**PLANNING COMMISSION AGENDA
THURSDAY, FEBRUARY 28, 2019
7:00 PM**

Subject: **Hartland Sports Center
 Site Plan Application #19-001–Request to construct an approximate 8,064 square foot addition to the existing Hartland Sports Center**
 Project site is located at 2755 Arena Drive, located north of Highland Road (M-59); (Tax Parcel ID #4708-22-300-044 and #4708-22-300-013)

EAST ELEVATION
SCALE: 1/8" = 1'-0"

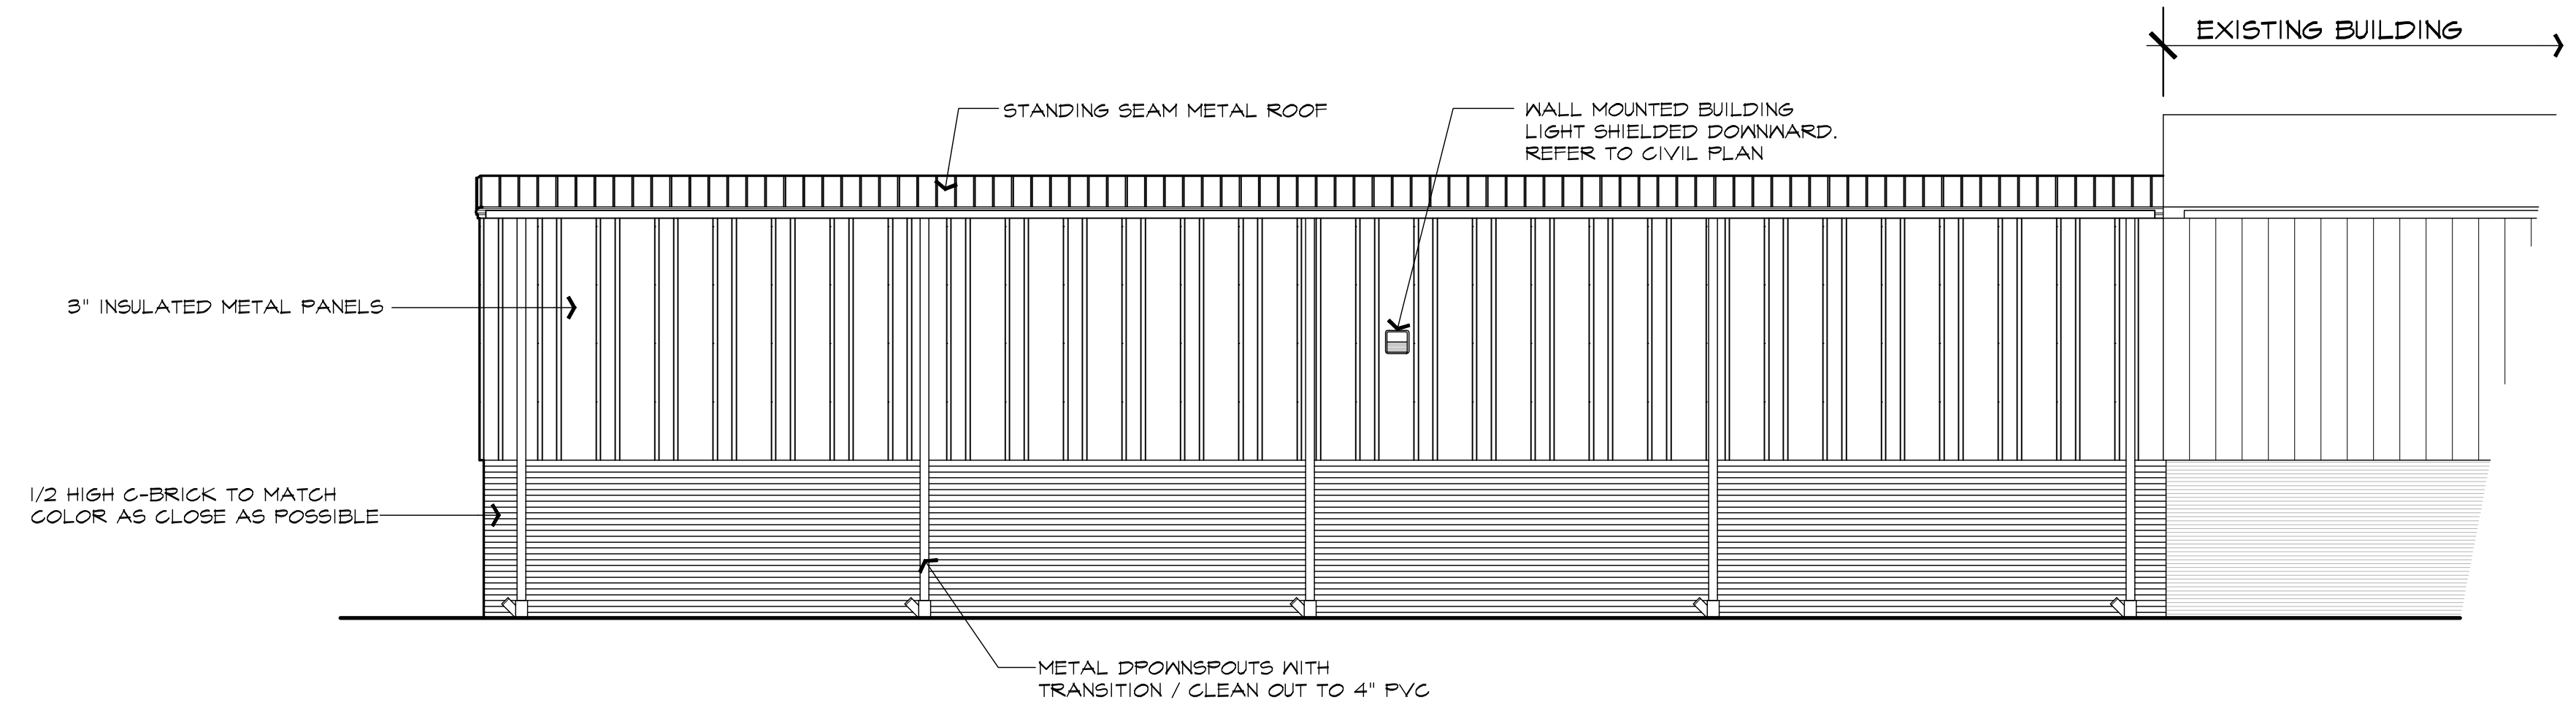
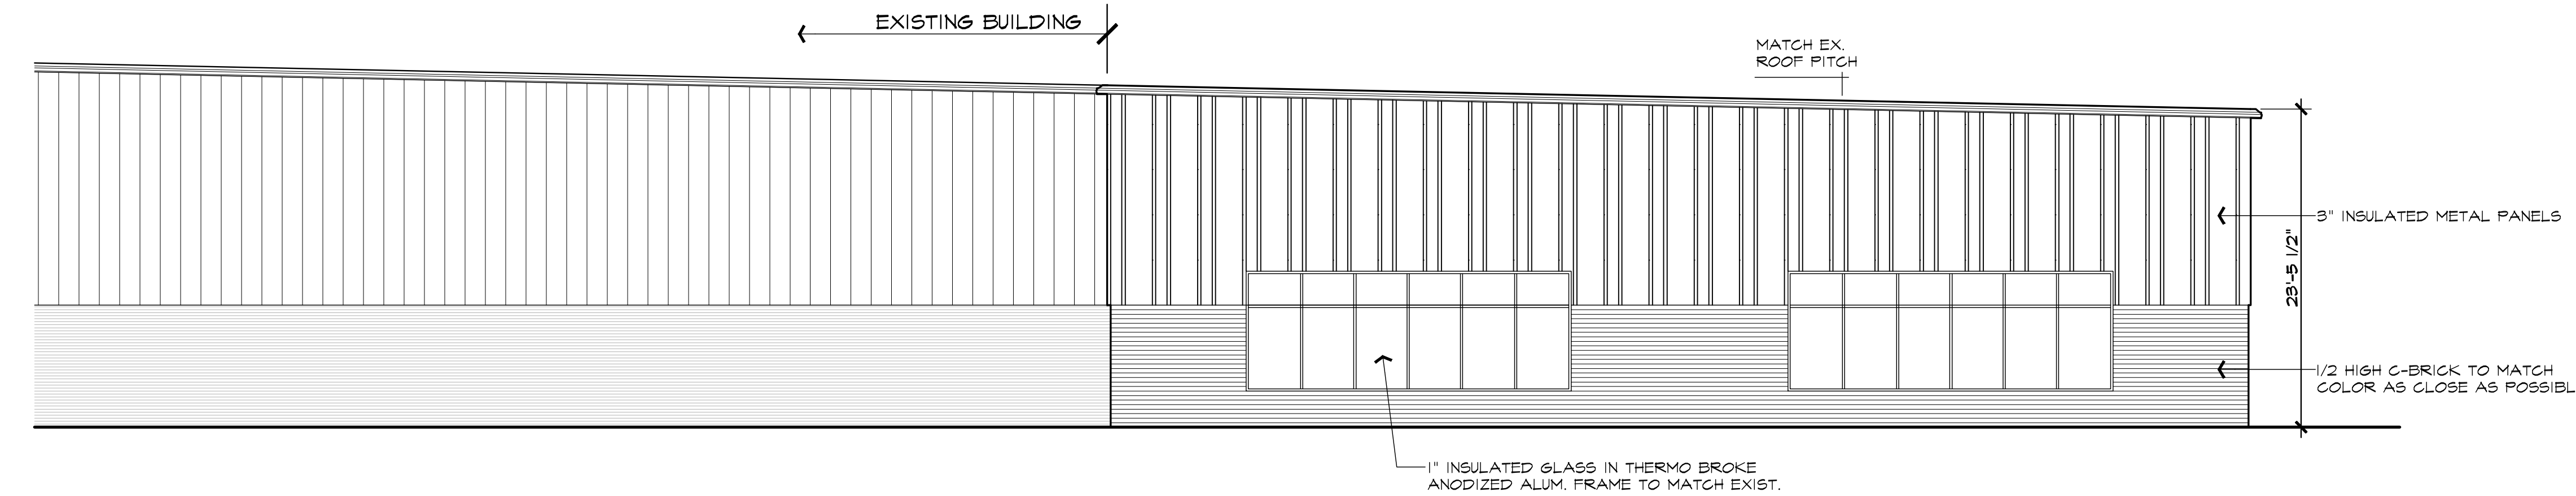
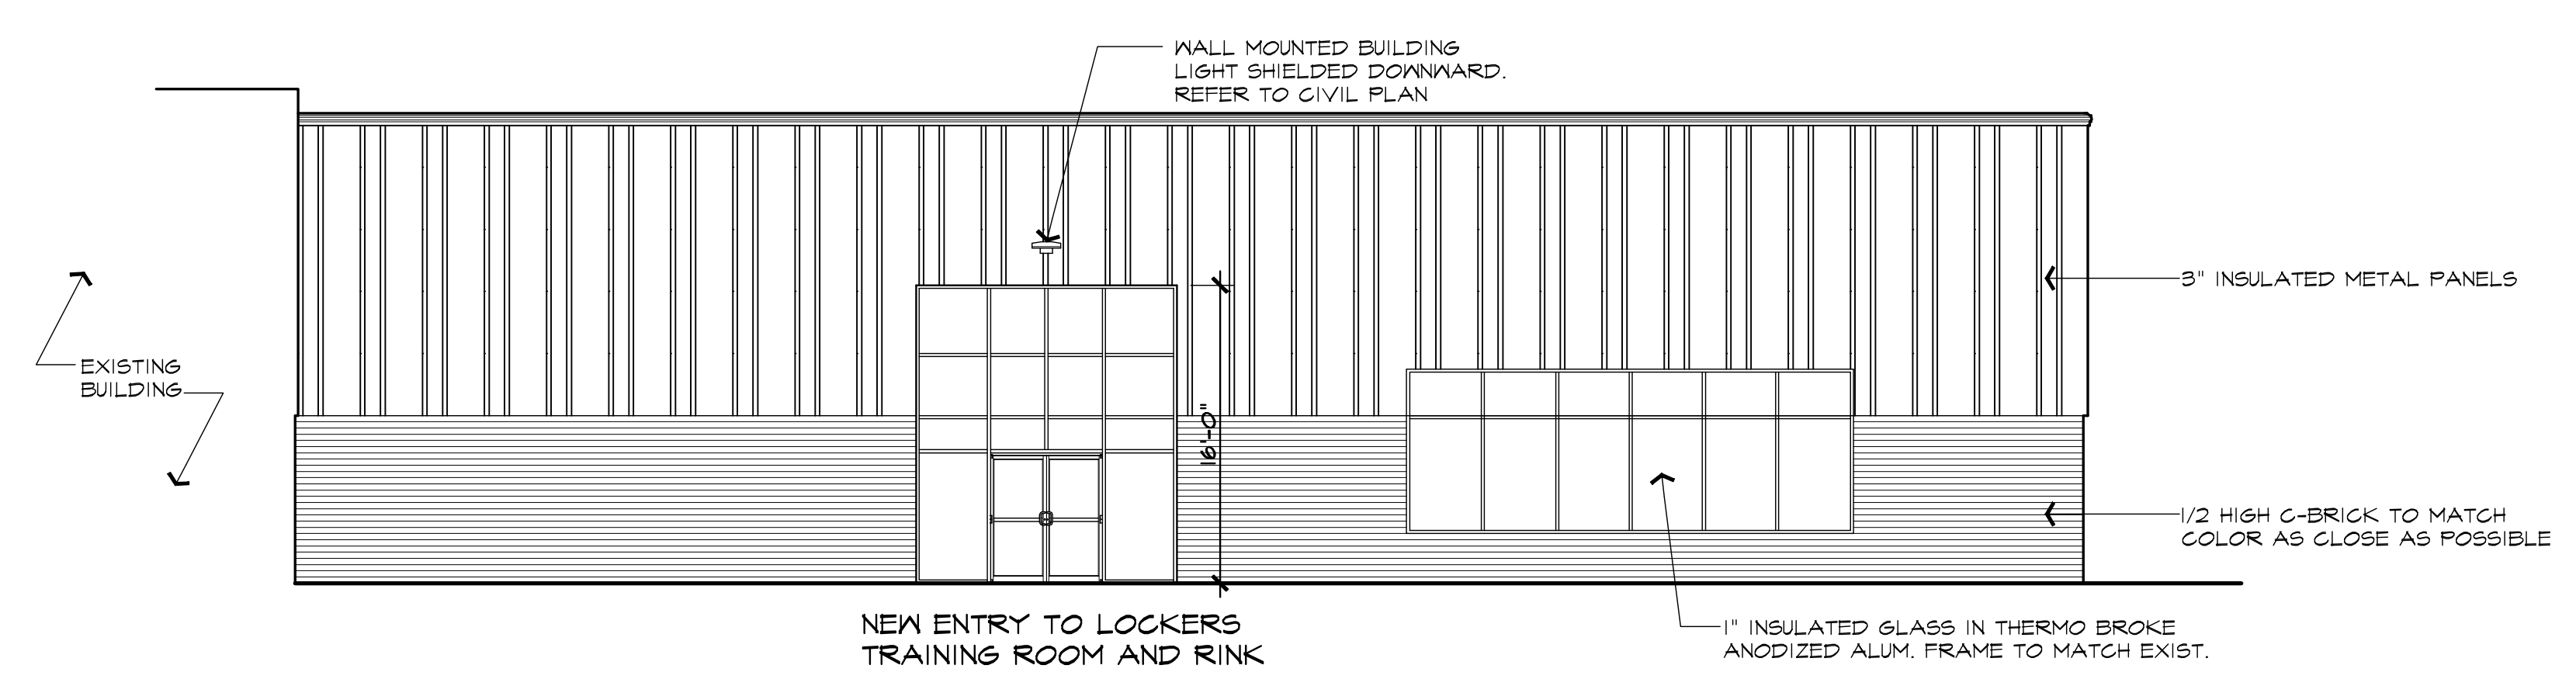
- Materials: percentages are listed for each elevation side; specifications on all materials are provided.
- Meets Requirement? – **TBD**
- Comment – **Planning Commission to determine if the proposed façade materials are acceptable. Historically the intent is to have building additions match existing façade materials (type and color).**
